Subject: Beaver Valley Power Station, Unit Nos. 1 and 2
BV-1 Docket No. 50-334, License No. DPR-66
BV-2 Docket No. 50-412, License No. NPF-73
Additional Information in Support of License Amendment Request Nos. 302
and 173 (Unit No. 1 TAC No. MC4645/Unit No. 2 TAC No. MC4646)

1. Additional Information: Long Term Core Cooling Transients for Proposed EPU Conditions (BVPS-1 and 2)

Additional Information: Long Term Core Cooling Transients for Proposed EPU Conditions (BVPS-1 & 2)

Figure-1 BVPS-2 1.5-Inch Break, RCS Pressure/Temperature Response, ARVs Only

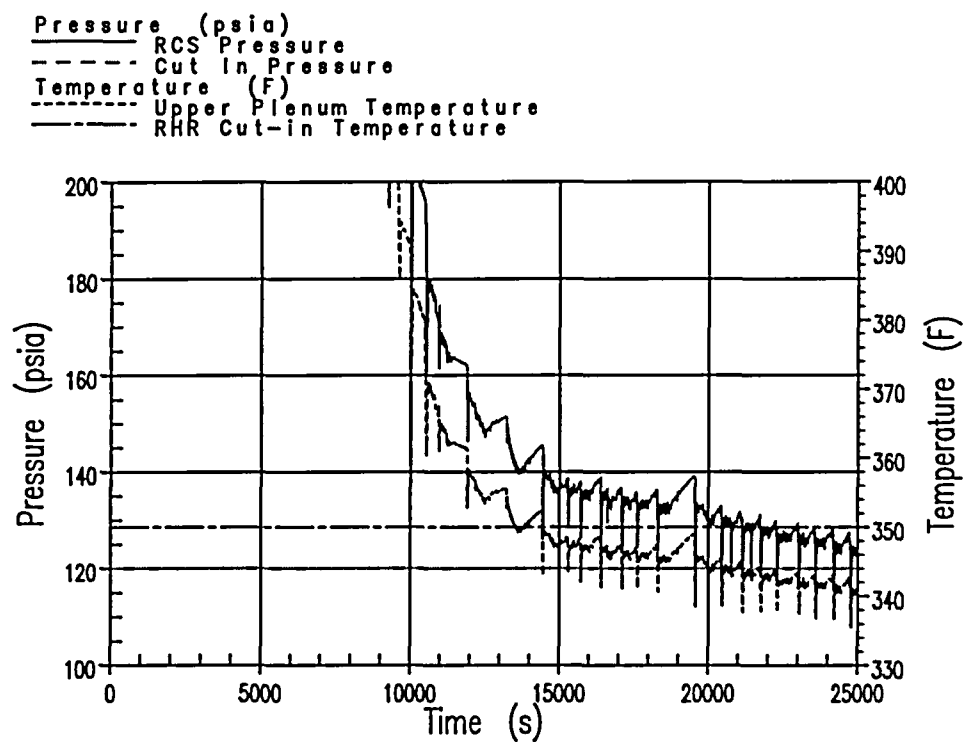
NRC review of the EPU LAR indicated that additional analysis relative to post-LOCA long term core cooling transients under the proposed EPU conditions was necessary.

Based on the NRC staff's review of the licensee's SBLOCA and post-LOCA long term cooling analysis, the NRC staff concludes that the Westinghouse NOTRUMP SBLOCA methodology and post-LOCA long term cooling evaluation, is acceptable for use for BVPS-1 and 2 in demonstrating compliance with the requirements of 10 CFR 50.46(b), under the proposed EPU conditions. The acceptability is contingent upon submission of additional analyses to show that small breaks can be cooled down to an RCS pressure of 120 psia, with a failure of one of the atmospheric dump valves. Or, show that for those breaks which cannot be depressurized below RCS pressure of 120 psia in order to flush the core that the RCS can be shown to refill and re-establish subcooled natural circulation. The necessary operator actions to facilitate a successful control of boric acid would also need to be included in the EOPs. If the RCS is shown to remain above 120 psia and boil for an extended time beyond the 6-hr. switch time, then additional EOP cautions or guidance would be needed to preclude the operators from an inadvertently rapid depressurizing with high concentrations of boric acid in the RCS.

The 1.5-inch cold leg break RCS cooldown and depressurization results are presented in Figure-1 and Figure-2. Figure-1 demonstrates the system response to the 1.5-inch cold leg break assuming that only the steam generator ARVs are utilized to perform the cooldown and depressurization function. As can be seen, the RCS temperature condition was achieved at approximately 14,000 seconds (3.89 hours) into the transient or 2.89 hours following the initiation of the RCS cooldown and depressurization. At 6 hours (5 hours after initiation of cooldown) the RCS had only depressurized to approximately 130 psia; therefore, in order to demonstrate acceptable depressurization to the desired RCS pressure of 120 psia, opening of the Pressurizer Power Operated Relief Valves (PORVs) is required. Figure-2 presents the same information assuming that three Pressurizer PORVs opened at 18,100 seconds (5.03 hours) to demonstrate that RCS depressurization can be achieved. As can be seen, RCS pressure can be reduced to below 120 psia approximately 600 seconds (10 minutes) after opening all three Pressurizer PORVs. The choice of 18,100 seconds to accelerate RCS depressurization using the PORVs was rather arbitrary and could have been commenced much earlier. It should be noted that even with the SG ARVs discharging and all three Pressurizer PORVs open, the RCS pressure stabilizes at approximately 110 psia under this analysis scenario. This is because the operable SG ADVs and PORVs are either under or close to critical flow conditions. If this were not the case, such as assuming either the BVPS-1 or BVPS-2 valve capacities with no failures, or assuming the availability of the condenser steam dump system, the RCS would be depressurized long before boric acid precipitation is a concern. Even under these circumstances, because of the high volume flow rates in the main steam system, RCS pressure will be slow to respond. This further reinforces the argument that no abrupt depressurization events can occur through either the ADVs or Pressurizer PORVs, thus RCS temperature remains high, promoting a very high boric acid solubility limit.
